Access Compliance Report

Public Rights-of-Way

(Curb Ramps)

Intersection ID: 27872	Main Street: BALLANTYNE_COUNTRY_CLUB_DR	Cross Street: LETHCO_WY	Location: NW
ADA ID: 66CCB22C0913	Ramp Type: Perp	Initial Pass/Fail: Fail	Overall Compliance: No
Codes/Mitigation Info/Possible Solution		Field Measurements/Component Compliance	
Severity Score: 13.75

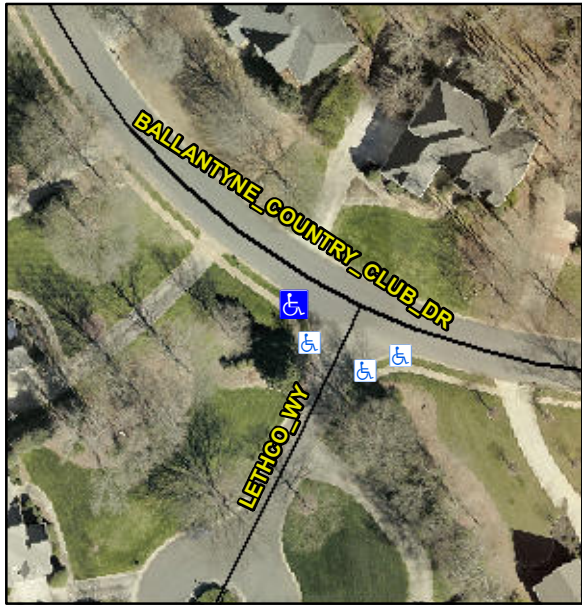
Not Found, R304.2.2, R304.5.3

Compliance		Description	Data	Compliance	Description	Data
N/A		Ramp Length (in)	50.0	No	Ramp Slope (%)	10.3
Yes		Ramp Width (in)	48.0	No	Ramp XSlope (%)	2.9
N/A		Flare Type LT	N/A	N/A	Flare Type RT	N/A
N/A		Flare Slope LT (%)	N/A	N/A	Flare Slope RT (%)	N/A
N/A		Flare Traversable LT?	N/A	N/A	Flare Traversable RT?	N/A
N/A		Landing Length (in)	N/A	N/A	DWS Provided?	N/A
N/A		Landing Width (in)	N/A	N/A	DWS Contrast?	N/A
N/A		Landing Slope (%)	N/A	N/A	DWS Length (in)	N/A
N/A		Landing X Slope (%)	N/A	N/A	DWS Full Width?	N/A
N/A		Landing Curb? (Y/N)	N/A	N/A	DWS Offset (in)	N/A
N/A		Shared Landing?	N/A			
N/A		Gutter Ponding?	N/A	N/A	Gutter Slope (%)	N/A
N/A		Gutter Lip Ht (in)	N/A	N/A	Gutter X Slope (%)	N/A
N/A		Painted X Walk1?	No	N/A	Painted X Walk2?	N/A
		X Walk 1 Direction	To NE		X Walk 2 Direction	N/A
N/A		X Walk 1 Width (in)	N/A	N/A	X Walk 2 Width (in)	N/A
		X Walk 1 Slope (%)	0.8		X Walk 2 Slope (%)	N/A
		X Walk 1 X Slope (%)	2.7		X Walk 2 X Slope (%)	N/A

Remove & Replace Entire Ramp.
